Project No. 07516-42-02  
February 9, 2022

Subject: ADDENDUM GEOTECHNICAL REPORT AND  
RESPONSE TO CITY OF SAN DIEGO REVIEW COMMENTS  
NAKANO  
SAN DIEGO, CALIFORNIA

<b>GEOCON</b> INCORPORATED <small>GEOTECHNICAL ■ ENVIRONMENTAL ■ MATERIALS</small> <small>6940 ANDERS DRIVE ■ SAN DIEGO, CALIFORNIA 92121-2974</small> <small>PHONE 858.558.4900 ■ FAX 858.558.4159</small>	SCALE 1" = 60'	DATE 02 - 09 - 2022
	PROJECT NO. 07516 - 42 - 02	FIGURE 1
	SHEET 1 OF 1

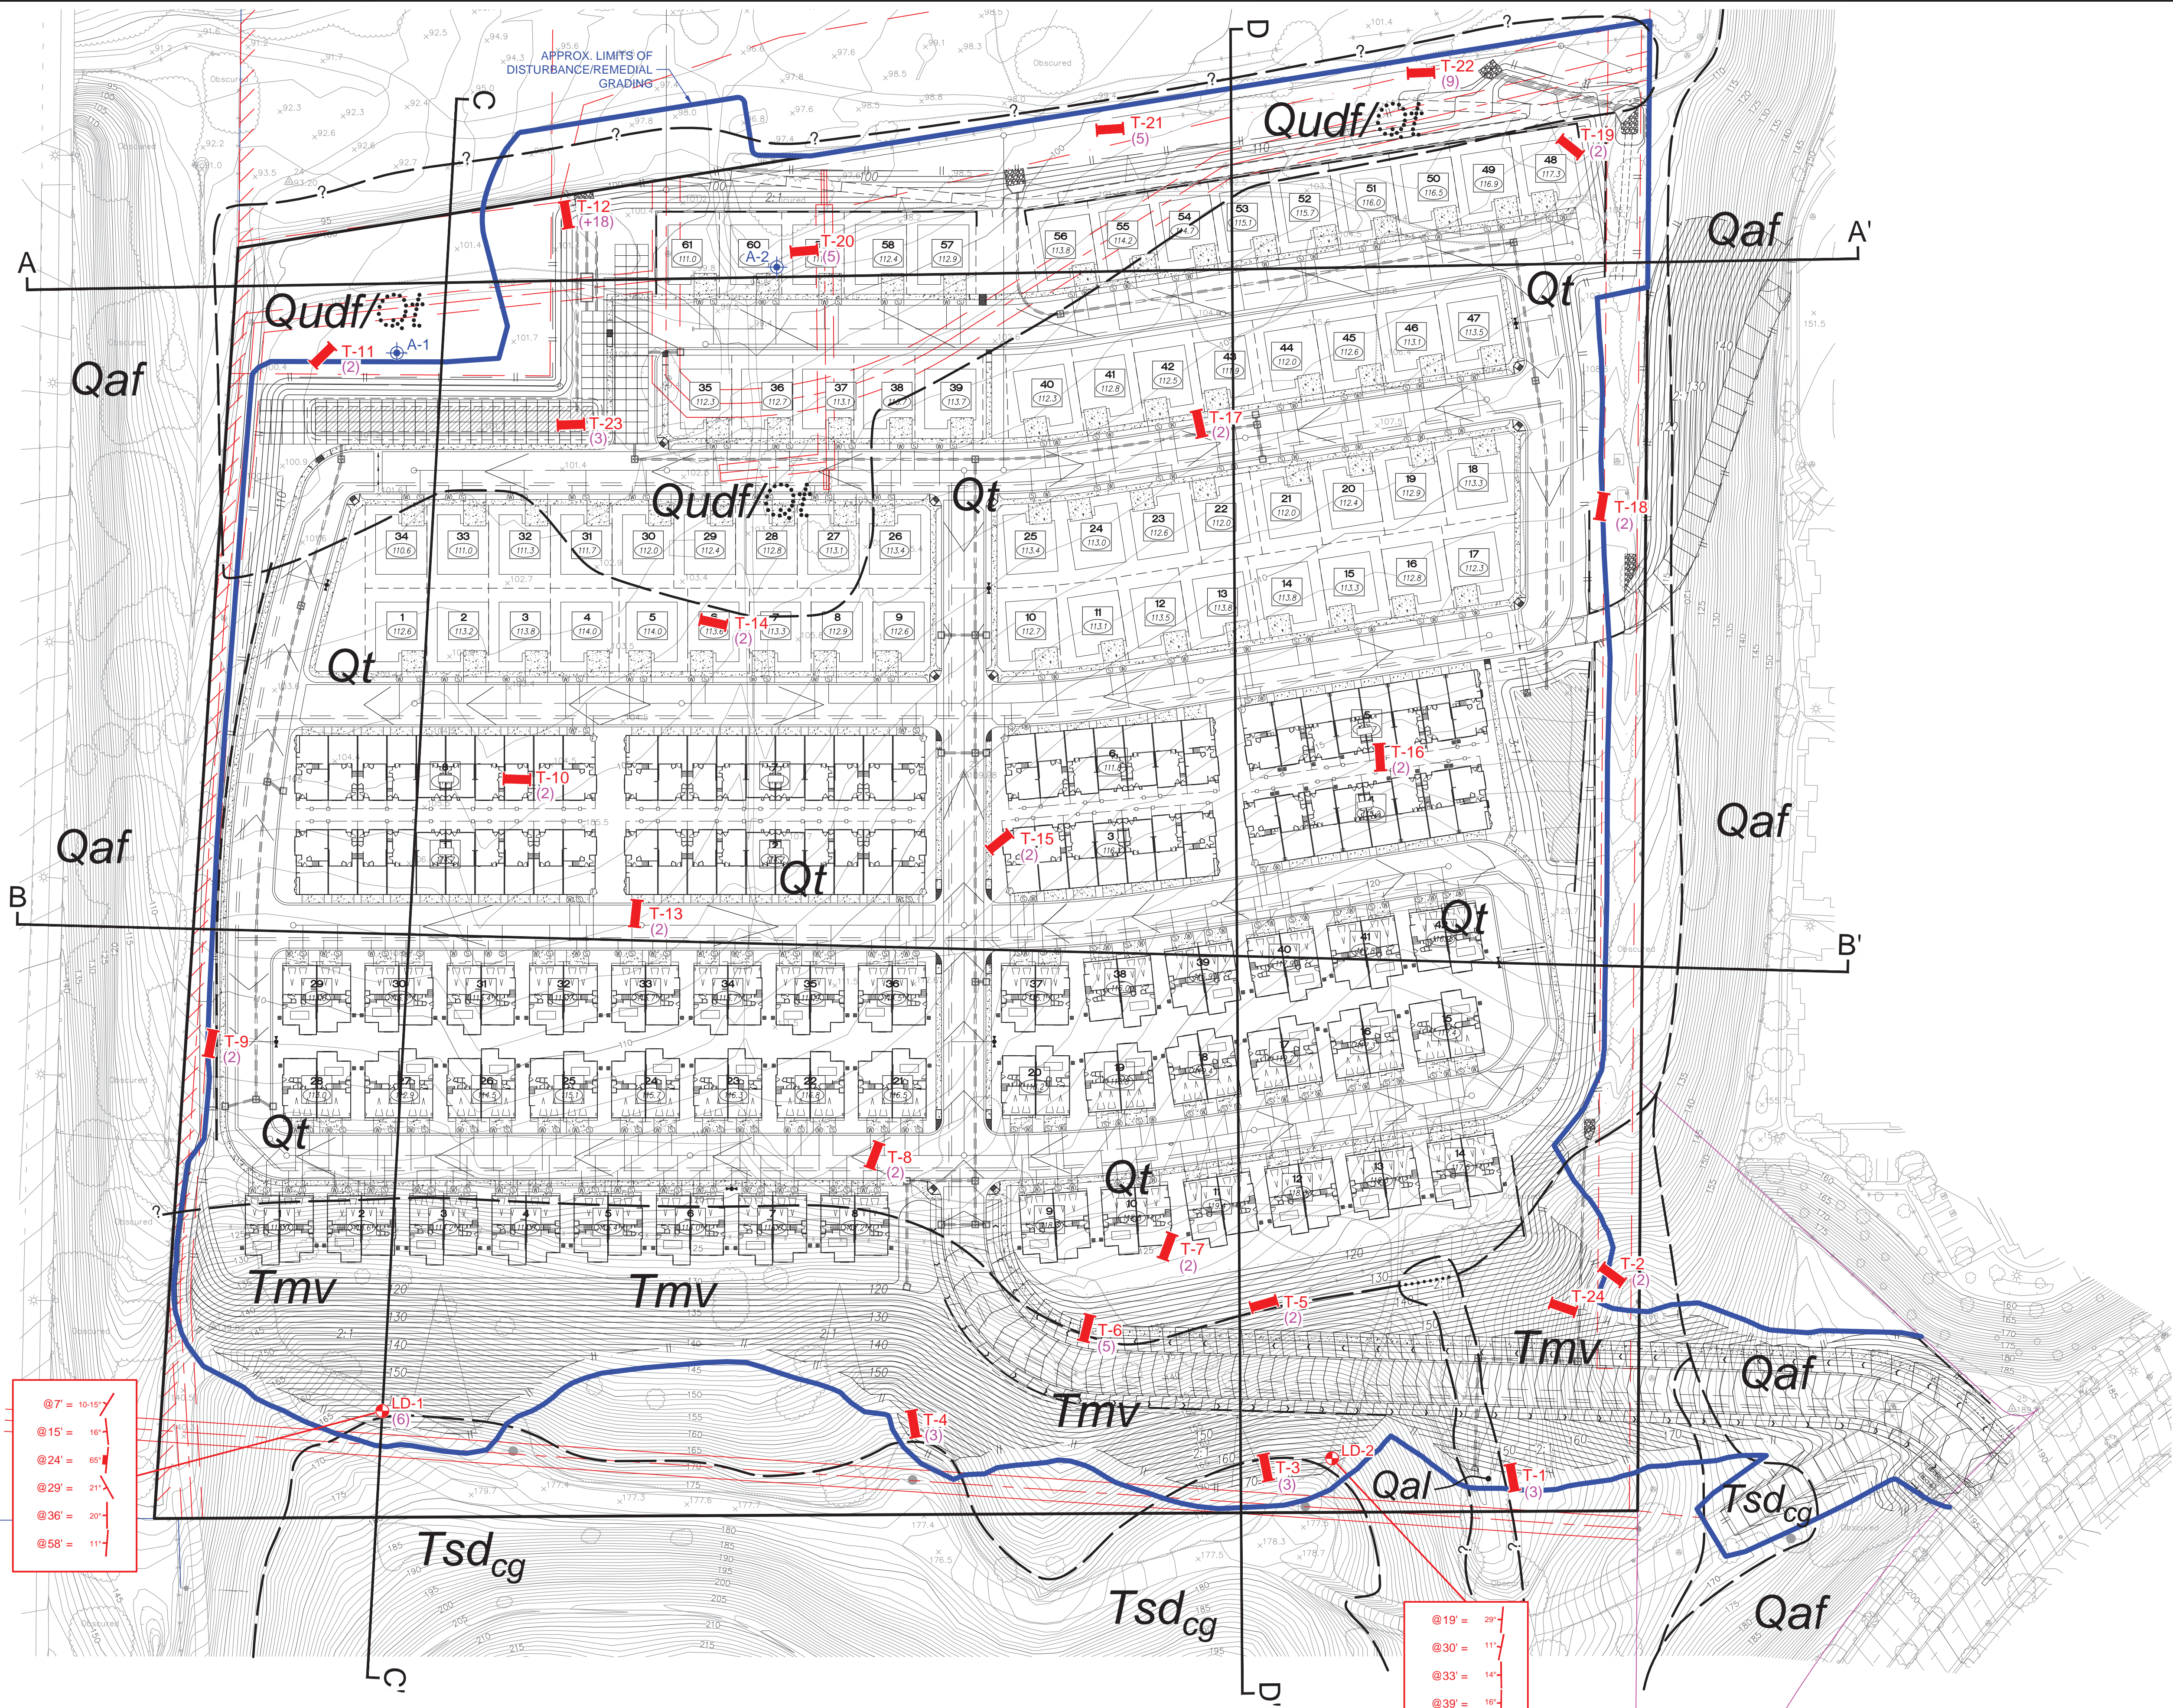
**Issue 4:** *Clarify if the southeastern corner of the subject property is underlain by a landslide (geologic hazard zone 22) with a rupture surface deeper than the extent explored in the test pits.*

**Response:** The southeast corner of the property is not underlain by a landslide. A second large diameter boring (LD-2) was drilled to a depth of 70 feet at the east end of the proposed cut slope (Figure 1 and appended boring log). The boring bottom elevation is approximately 16 feet below proposed pad grade at toe of slope. Observations made during downhole logging show similar geologic conditions to those observed in LD-1, i.e., a massive to poorly bedded very fine-grained silty sandstone dipping approximately 14 degrees due west. There are no slide planes, bedding plane shears, or other geologic features indicative of landsliding present in LD-1 or LD-2.

Additionally, we excavated an additional test pit (TP-24) downslope of TP-2 to confirm the geologic conditions present in the smaller cut slope at the southeast corner of the project. The geologic unit and structure observed in TP-24 are consistent with the conditions observed in LD-1 and LD-2. Boring and test pit logs for LD-2 and TP-24 are included with this report.

**GEOLOGIC CROSS-SECTION C-C'**  
SCALE: 1" = 60' (Vert. = Horiz.)

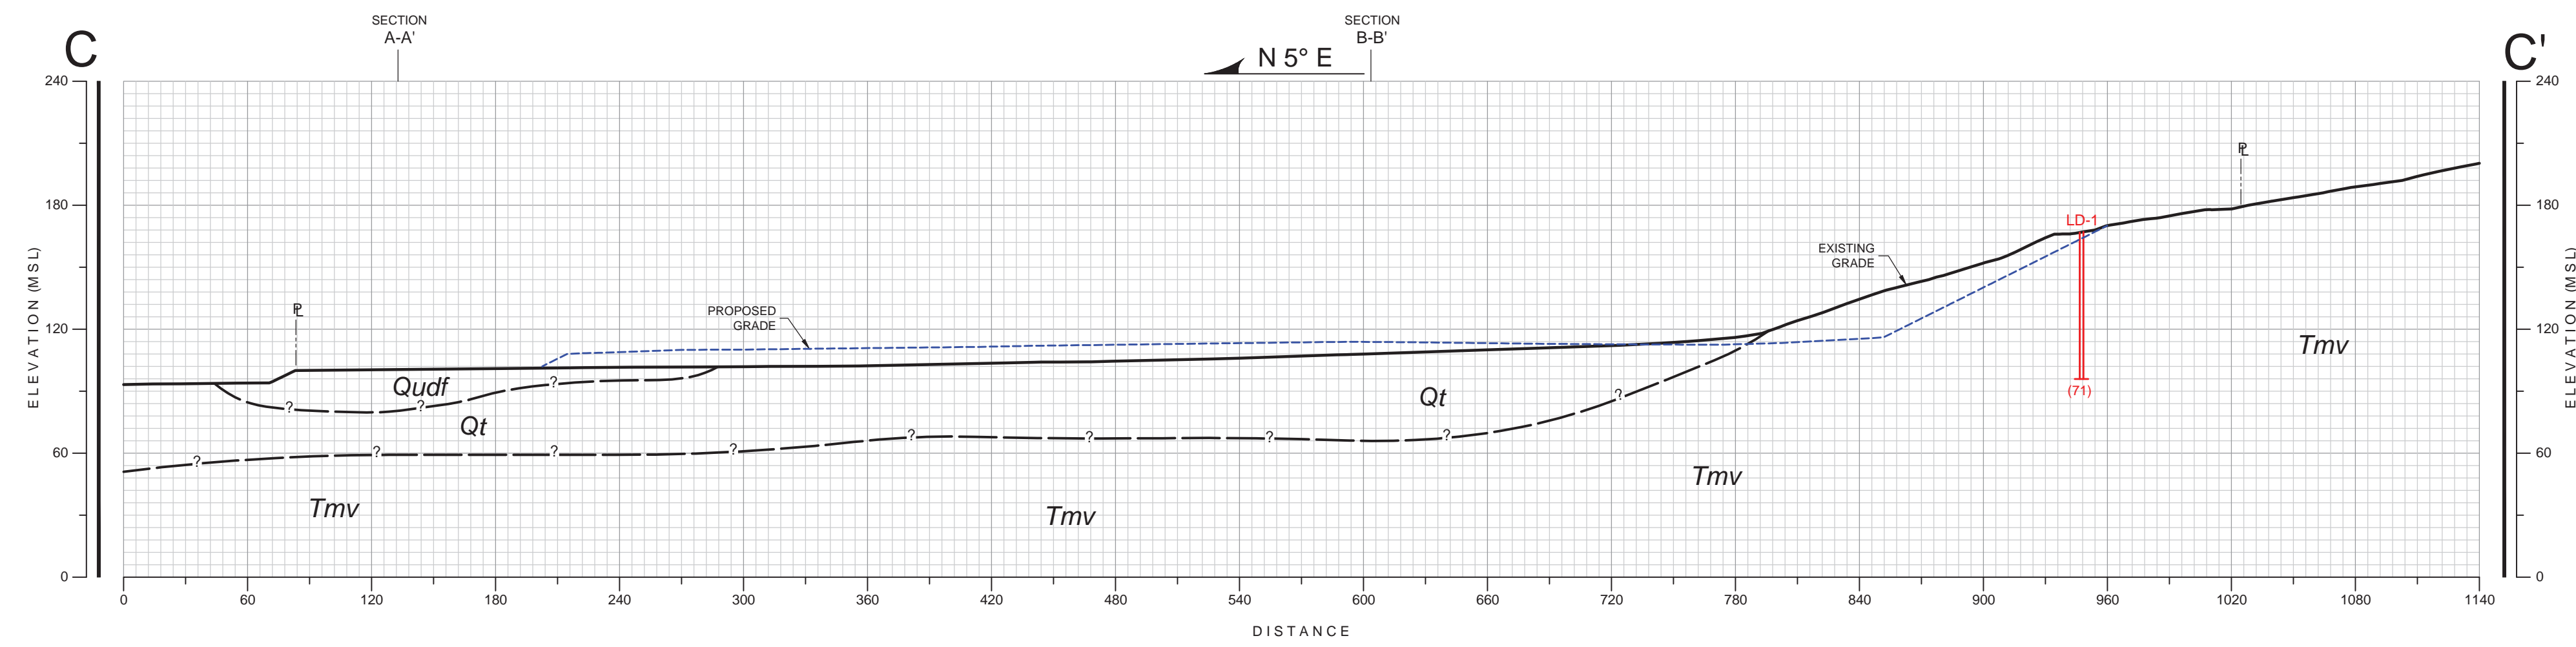
**Issue 5:** *Per the State's Guidelines for Evaluating Seismic Hazards in California (2008), the commonly accepted factor of safety for slopes is >1.1 for dynamic loads. The projects' geotechnical consultant should demonstrate that the site will comply with this standard following project completion.*

Using the parameters discussed herein, an equivalent site acceleration,  $k_{EQ}$ , of approximately 0.1g was calculated (see Figure 4). Using this  $k_{EQ}$ , we get a factor of safety of 1.86 for Section C-C' (see Figure 5) and 2.2 for Section D-D' (see Figure 6). A slope is considered acceptable by the screening analysis if the calculated factor of safety is greater than 1.0 using  $k_{EQ}$ ; therefore, the slopes pass the screening analysis for seismic slope stability.
